RE: EM-CING-084-150416  
Notice of Completion of Construction & PE Certification for Cingular  
Wireless/AT&T facility at: 234 Melba Street, Milford, CT  
(ATT NO. CT5601)

**Subject:           Modification Inspection Report**

<b>Crown Castle Designation:</b>	<b>Crown Castle BU Number:</b>	825998
	<b>Crown Castle Site Name:</b>	Milford Shore Area
	<b>Crown Castle JDE Job Number:</b>	245639

<b>Site Data:</b>	<b>234 Melba Street</b>
	<b>Milford, CT 06460</b>
	<b>N 41° 12' 36.018", W 73° 1' 8.45"</b>
	<b>125 Foot Monopole</b>

T-MOBILE SITE CT11209D MILFORD SHORE AREA  
PROJECT: 234 MELBA STREET MILFORD CT  
SUBJECT: ATTACHMENT #1 AS BUILT WELDS

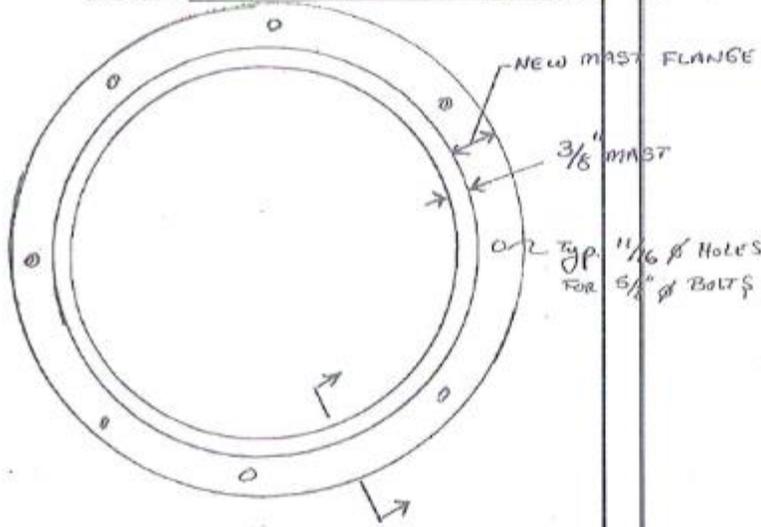
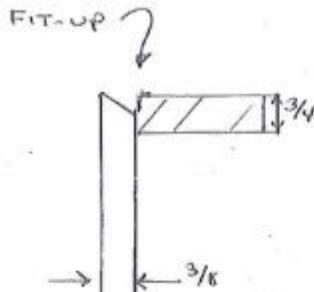
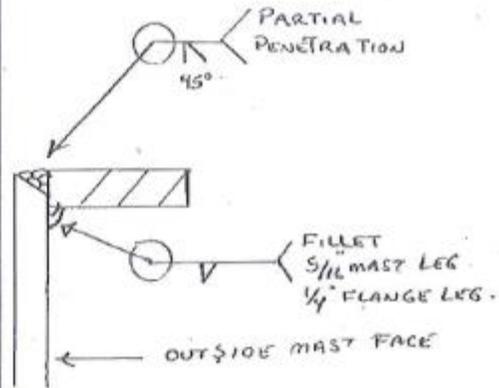
- I) Reinspection of tower base 1 1/4" thick stiffeners marked PL-1 at four (4) locations.
  - A) Due to corrective welds made to items marked on report, dated 12-22-14, items were reinspected.
- II) Elevation 85'± Splice Detail B/S-5 for new flange added at top of existing mast where existing flange was removed.

- A) Inspector's Drawing S-5 shows new 1 1/2" thick flange with 1" diameter A325 bolts.

Installer's Drawing S-3 shows 3/4" thick flange and 5/8" diameter bolts.

Installation used requirements of S-3 (3/4" plate flange) upper sections not added at time of visit.

- 1) Mast bevel inward - new flange fits partly down around outside mast face. Bevel was filled with weld for depth of  $\frac{3}{8}$ "±. Exterior overhead fillet weld added between mast exterior face to underside of new flange. Resulting fillet weld is 5/16" leg to mast and ¼" to flange. Flange weld held back (smaller) to avoid bolt holes.

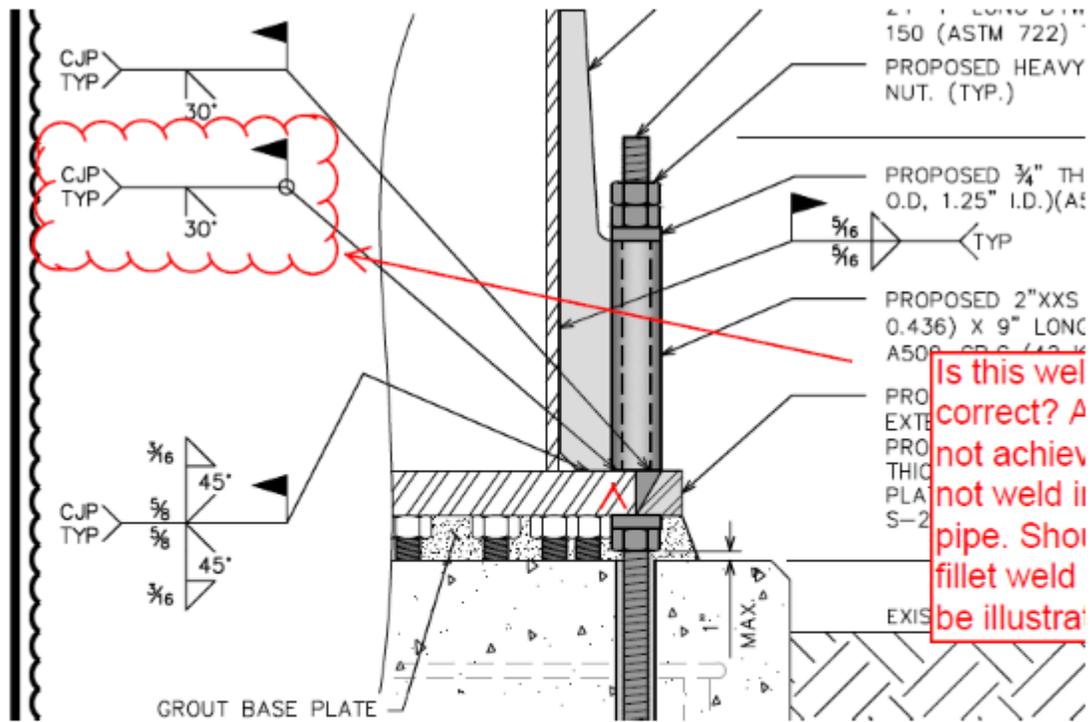
I could I get a little clarity for the weld symbols on page S-3 of the CD's, the symbol(CJP) I am referencing is addressing the 2"xx pipe to base plate connection; that particular type weld would be un-achievable. (see snippet)

**PUNCH ITEM 4**

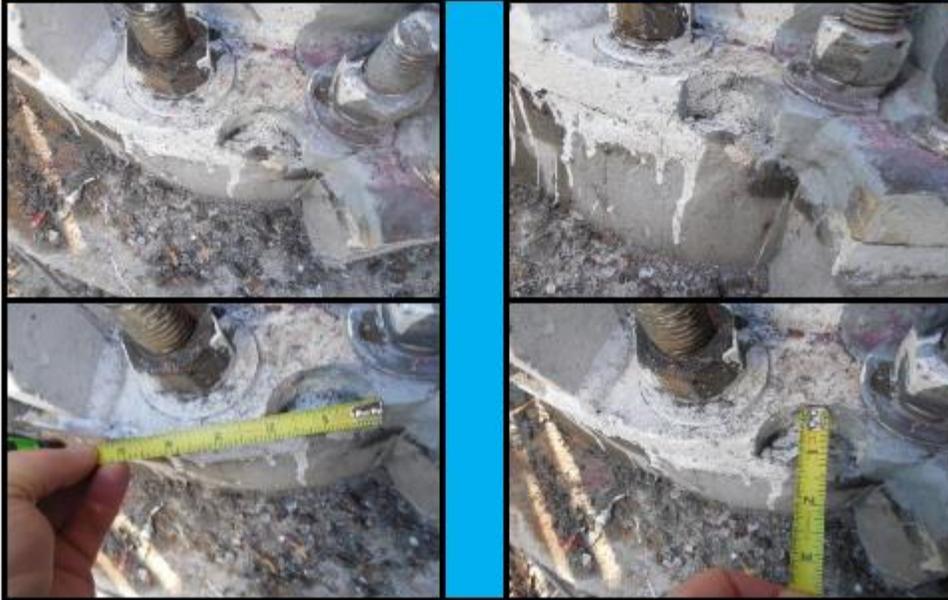
**DISCREPANCY:**

A 2" x 1 1/2" notch has been cut in the base plate. The notch located 2 1/2" to left of the North East anchor rod.

### PUNCH ITEM 7

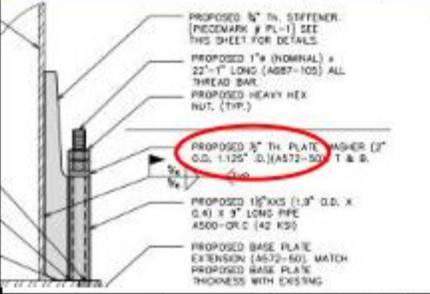
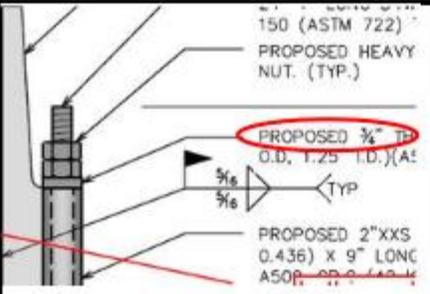
**DISCREPANCY:**

We have conflicting information regarding the washer thickness to be used, please see drawing snippets below. The washer plate measured 3/4" thick.

### PUNCH ITEM 8

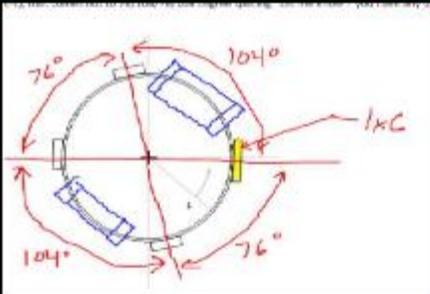
HEIGHT	FLAT/ARC	PLATE #	PLATE HT START/STOP	DRAWING PG #																				
	See Below	1		S-4																				
<b>DISCREPANCY:</b>																								
<p>The EOR approved the below separations for the newly installed splice plate. The plate separations observed are listed below</p> <ul style="list-style-type: none"> <li>- North plate – North East plate = 1'-1"</li> <li>- North East plate – South East plate = 1'-3"</li> <li>- South East plate – South West plate = 1'-2"</li> <li>- South West plate – North plate = 1'-4"</li> </ul>																								
<b>ACTIONS NEEDED BY GC:</b>																								
Obtain EOR approval for existing condition or install per modification drawings.																								
<b>PHOTOGRAPHS</b>
